Beverage Systems

## Technical Service Bulletin

TSB-Y10-009

Vent Tube Configuration Change

Picture 1  
“L” Shaped Pressure relief vent tube assembly  
(Shown on vessel equipped with Sure-Fill™ feature.)

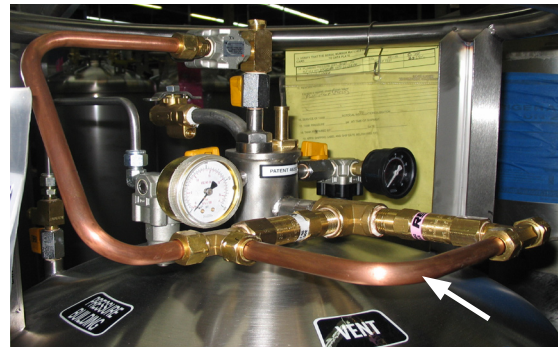
Beginning October 1, 2007 all beverage CO<sub>2</sub> storage systems will be manufactured with an “L” shaped pressure relief vent tube (shown in picture 1) rather than with the “C” tube configuration (shown in picture 2.) The configuration will be the same whether a vessel is equipped with or without the Sure-Fill™ feature. The purpose of this change is to prevent the vent tube from possibly dislodging from loose compression fittings while the vent circuit is pressurized during Sure-Fill regulator or relief valve operation.

The vent tube in either configuration will not dislodge from the compression fittings when it is properly tightened, maintained, and undamaged. Chart recommends a periodic inspection of any vent circuit for proper tightness.
